**CALIFORNIA COASTAL COMMISSION**

## **A-5-LGB-19-0015 (LAGUNA CANYON CREEK EROSION)**

**OCTOBER 17, 2019**

### **EXHIBITS**

NOTES:  
1. ANGLE MATS WILL BE CONSTRUCTED BY OMITTING THE REQUIRED UNITS SO THE REQUIRED MAT DIMENSIONS CAN BE OBTAINED.

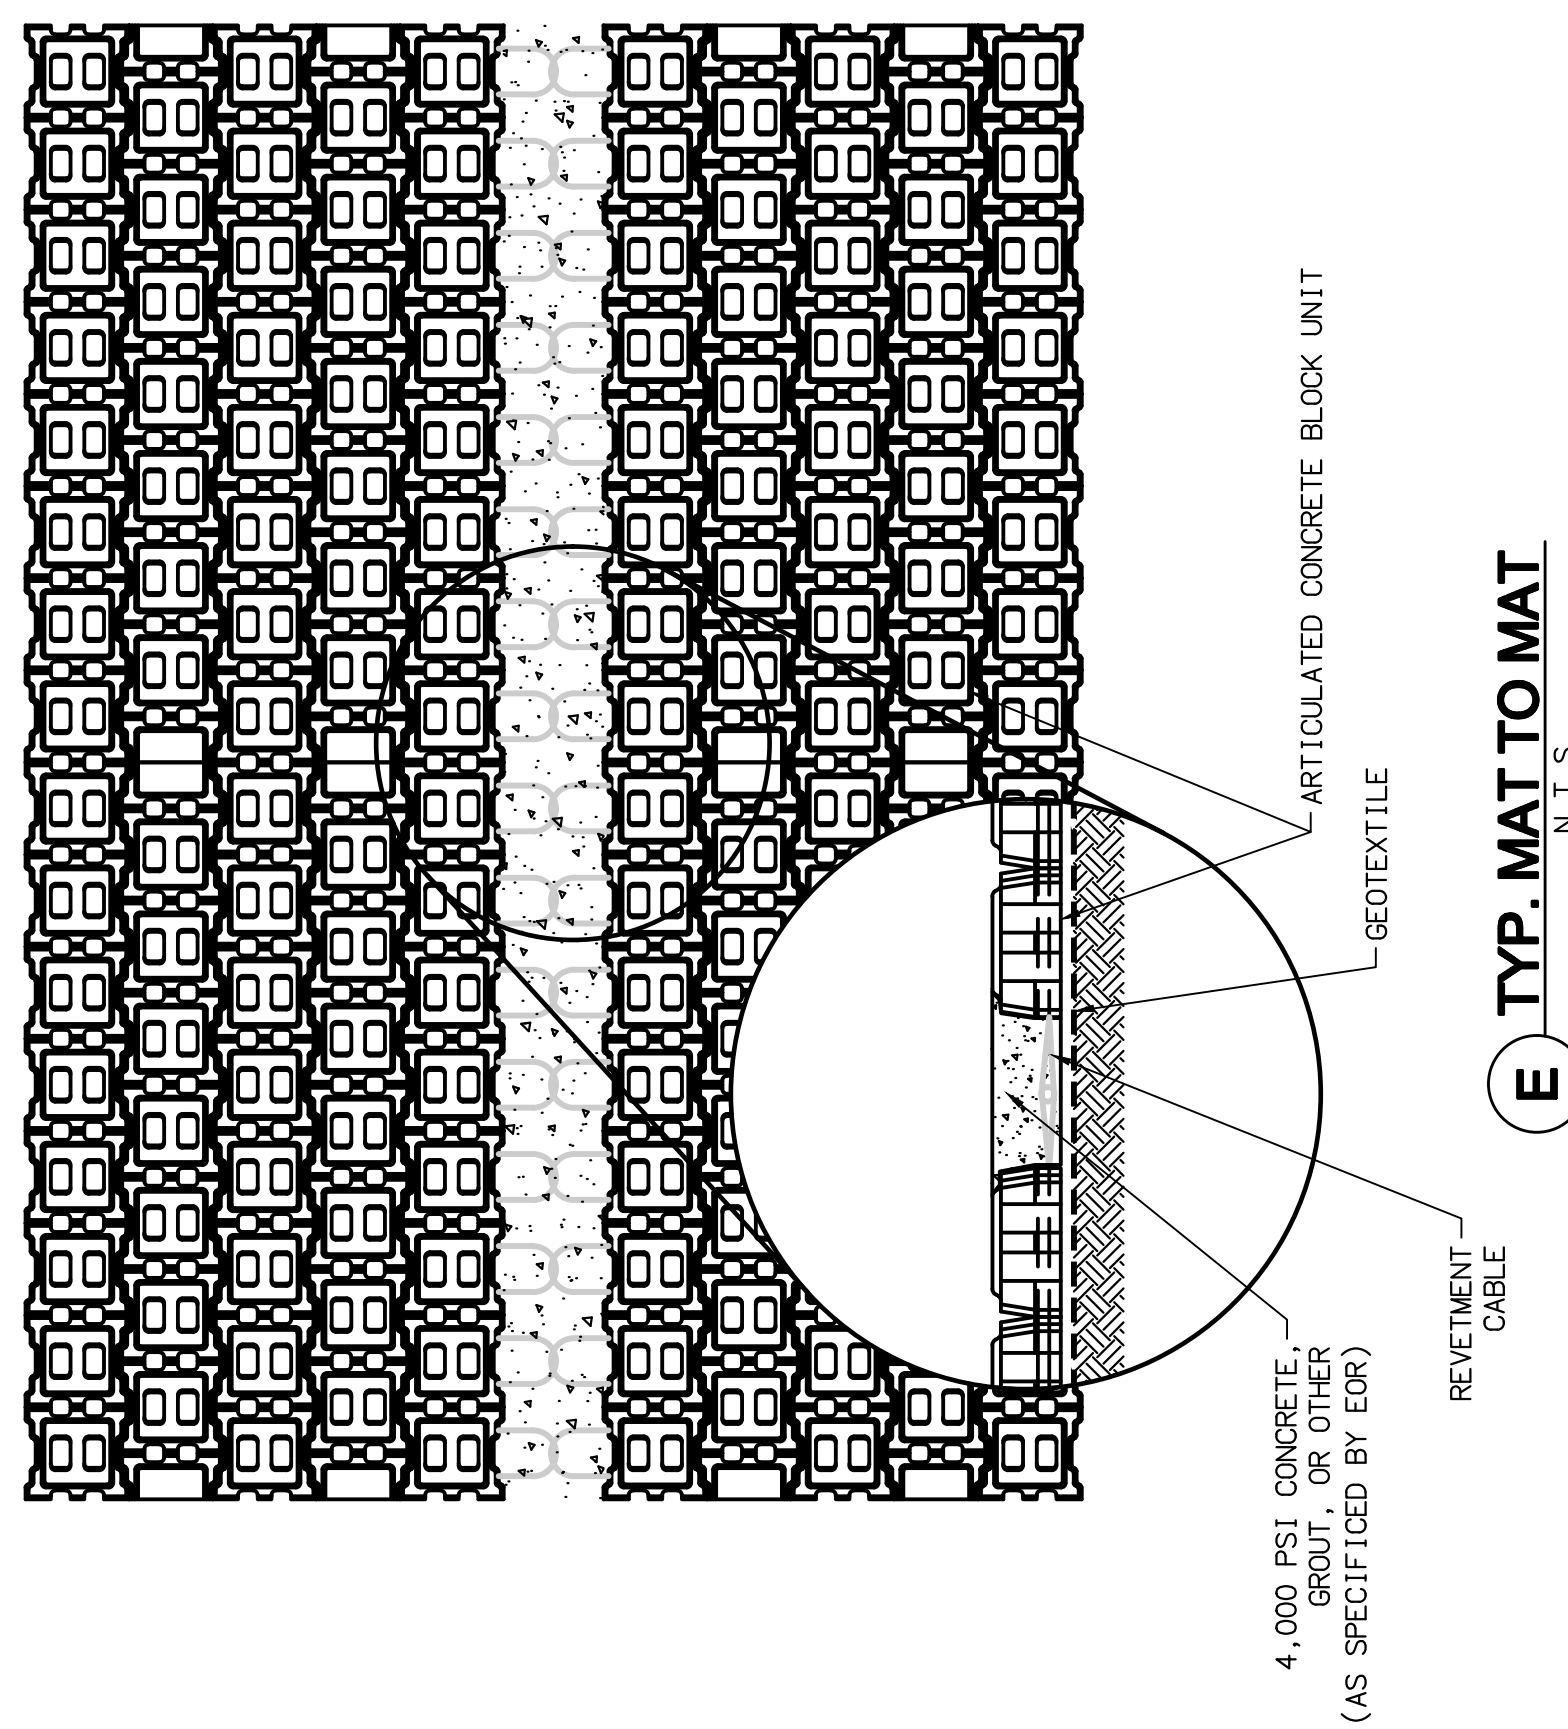
The proposed articulated concrete block (Armorflex) lining along both channel banks immediately north of the existing vehicular access bridge is required in order to prevent and control erosion of the creek banks. The channel floor remains a soft bottom, and the proposed Armorflex product

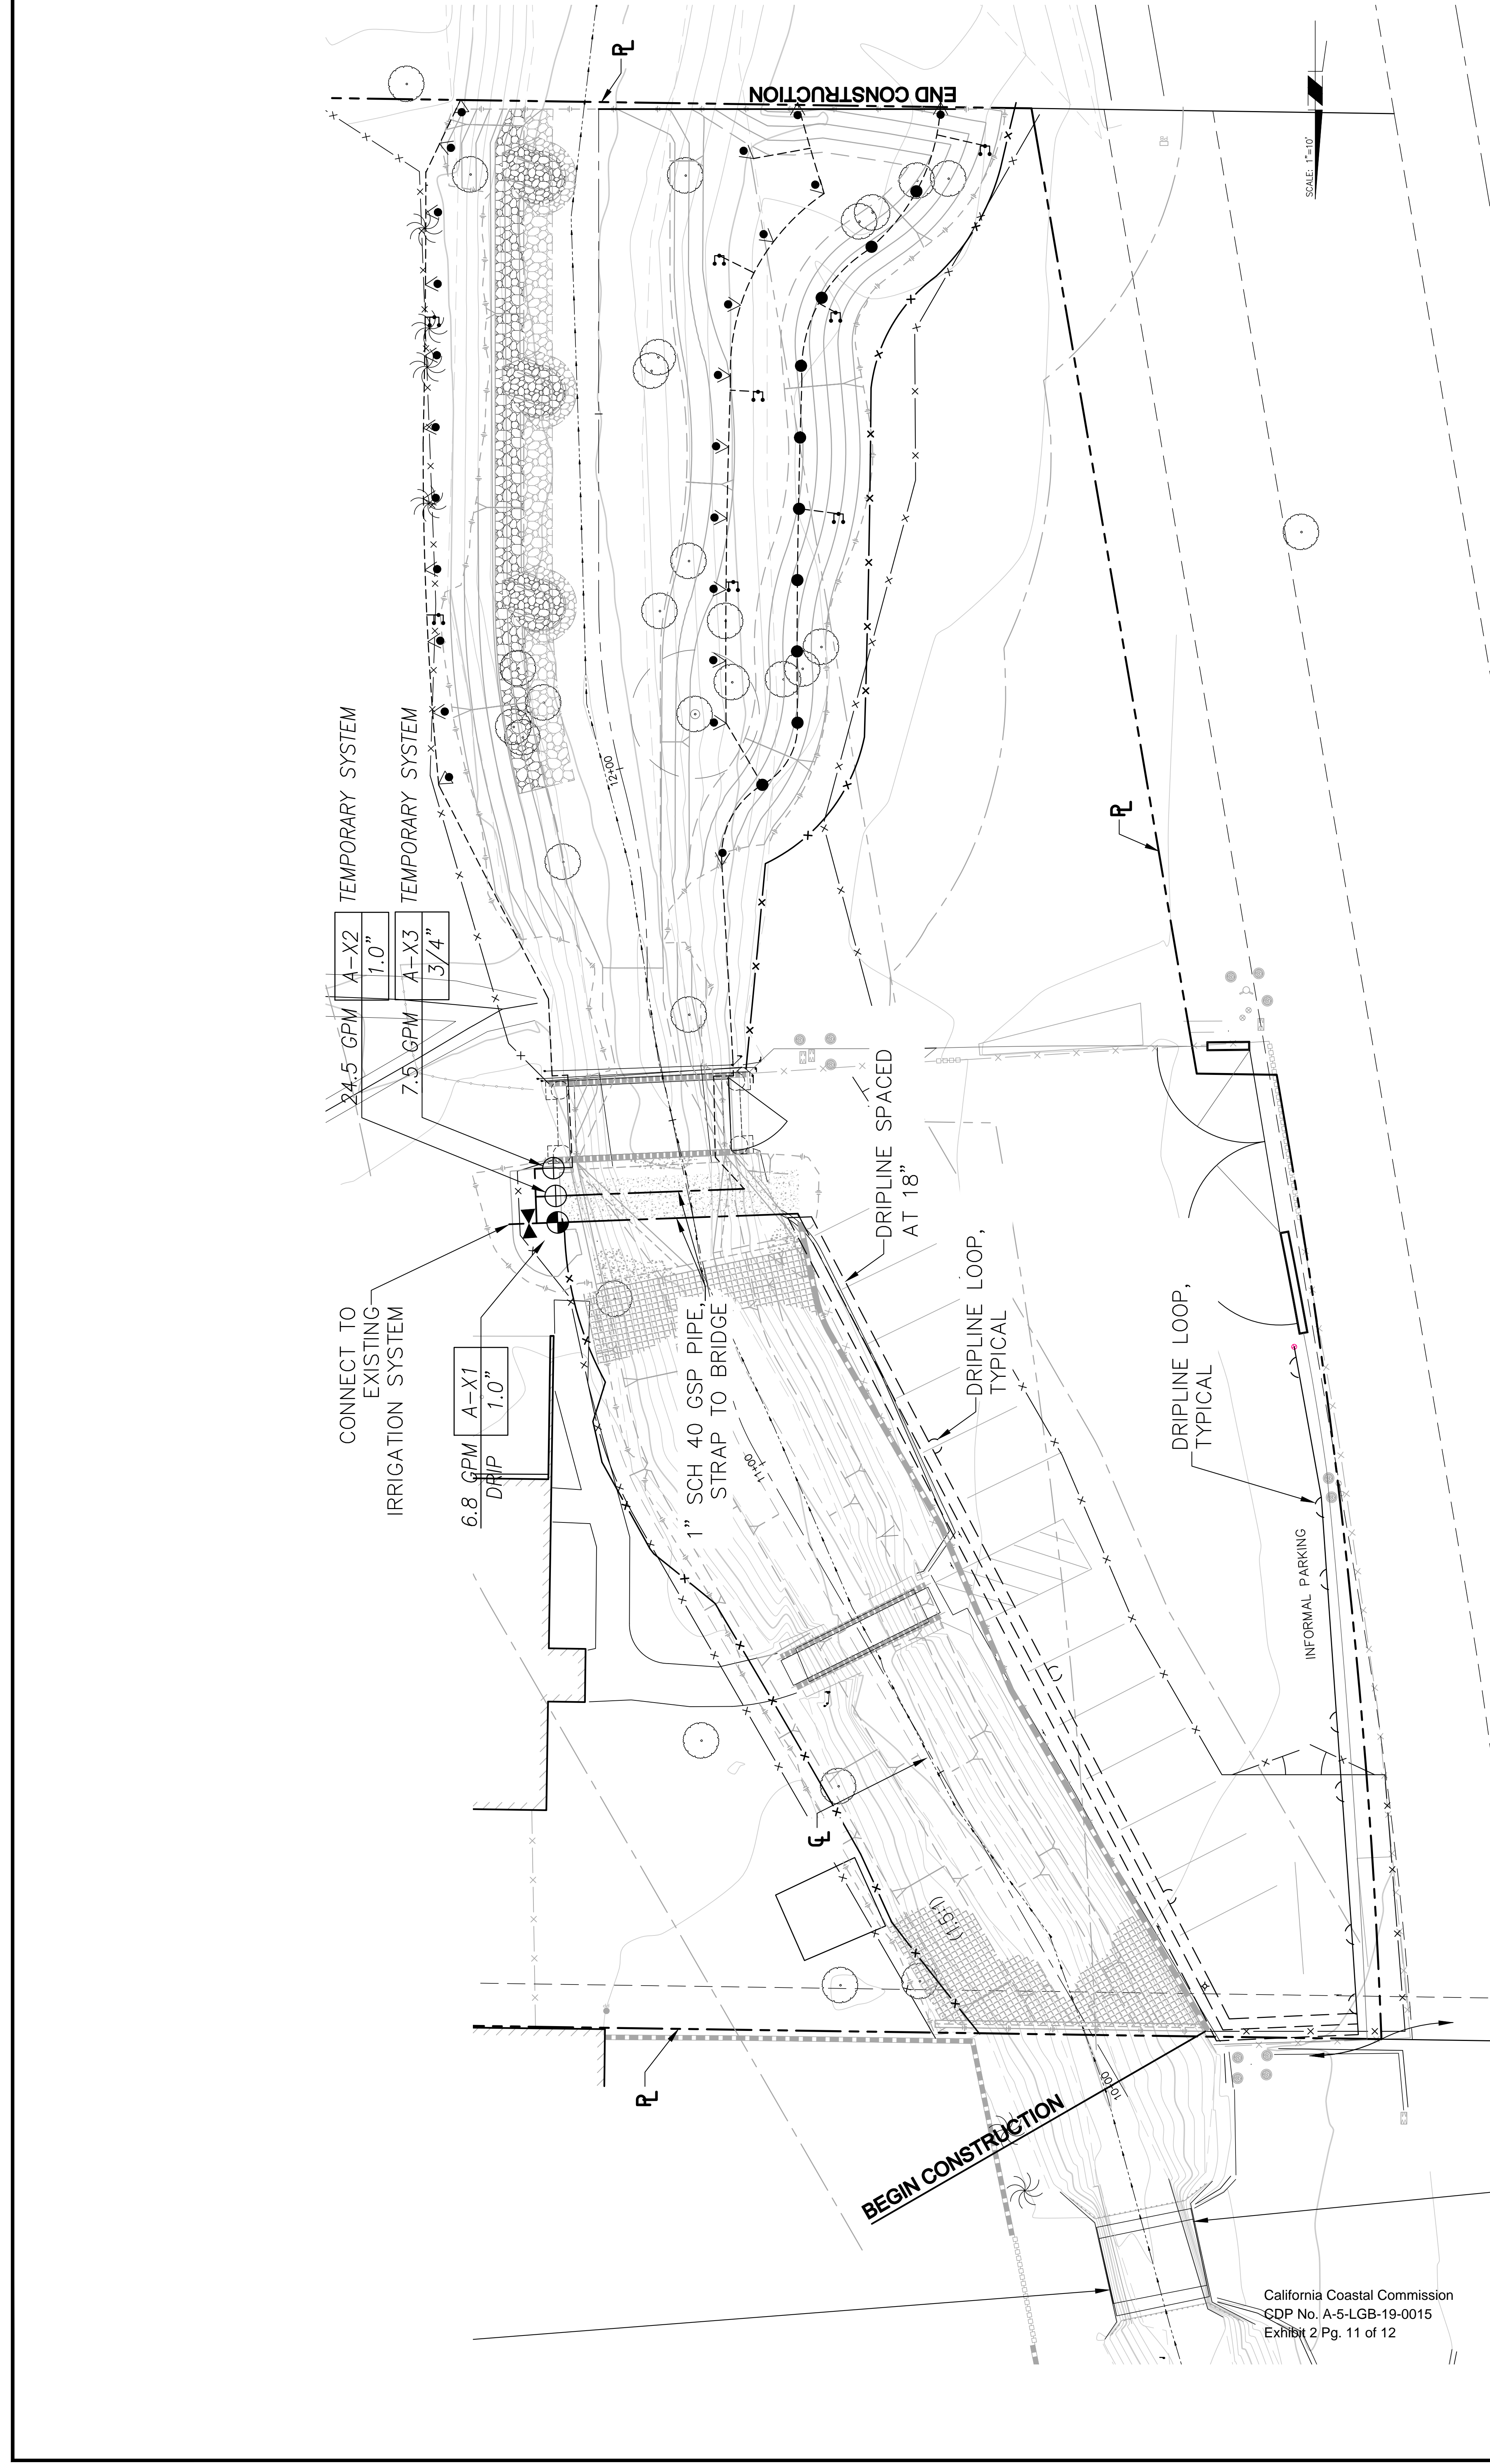
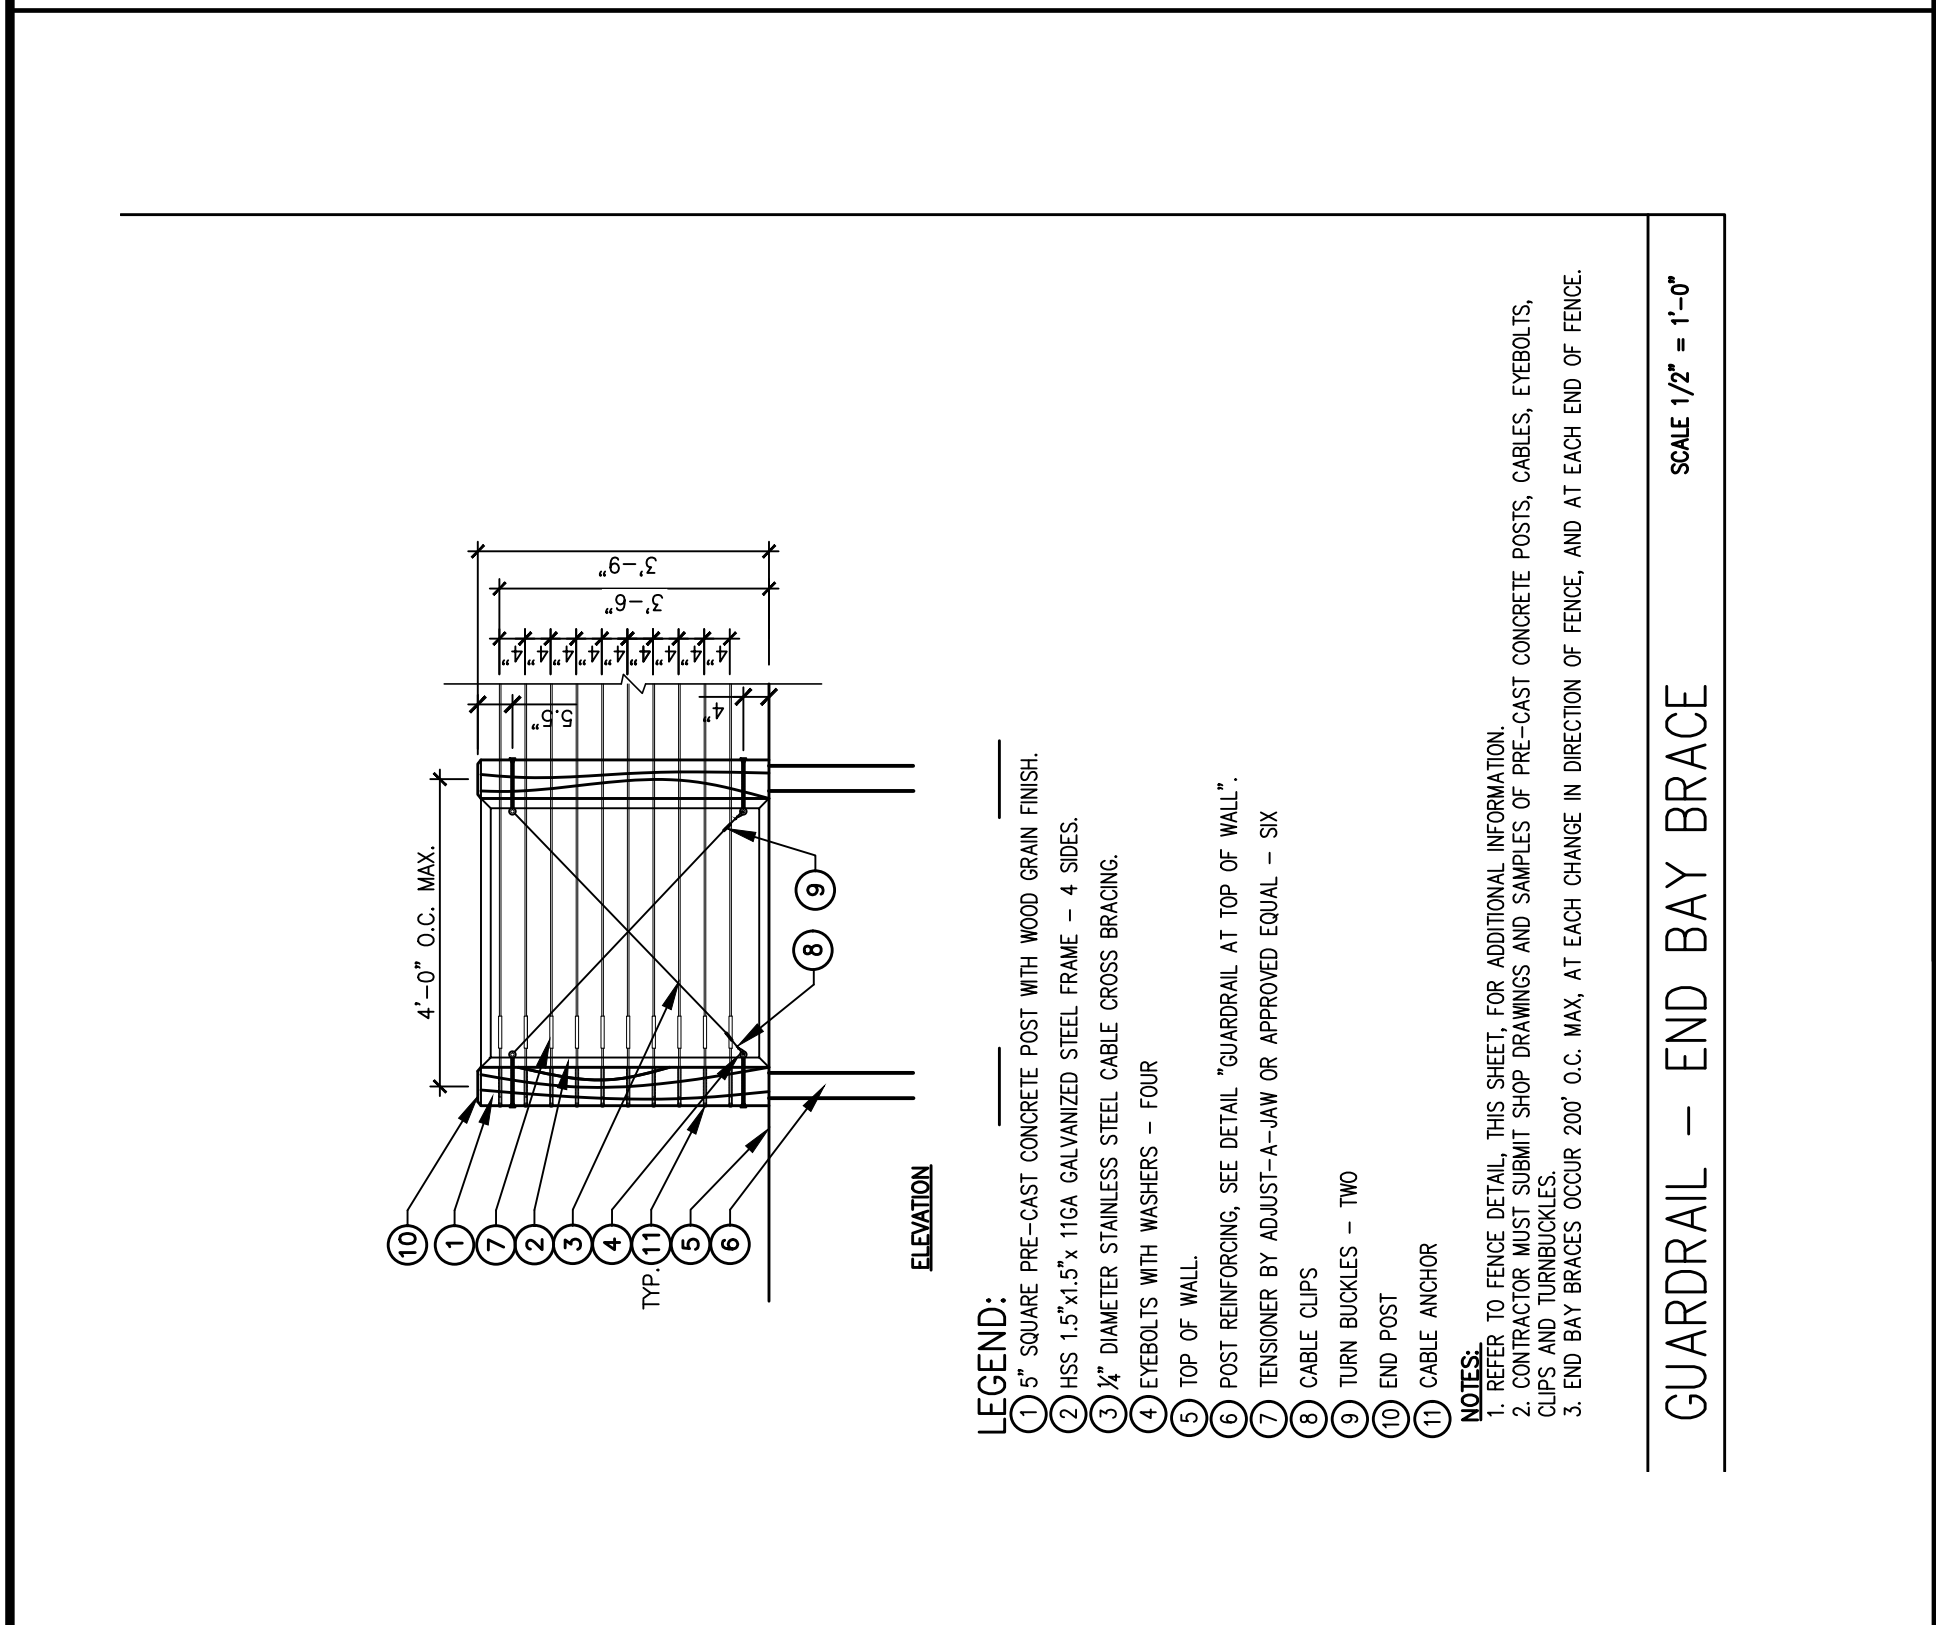
The proposed pedestrian bridge will be a conventional steel truss bridge with a weathered look to blend in with the surrounding environment (see plan sheet 5). The cable railing is attached to wood-textured concrete posts that will be mounted on top of the retaining wall. Cable railing was chosen to minimize view impacts. The retaining wall will be dark tan split-face masonry finish. The perimeter fence will be of a wood fence cross-buck style. All the finishes will contribute to enhance the natural aesthetic of the creek environment.
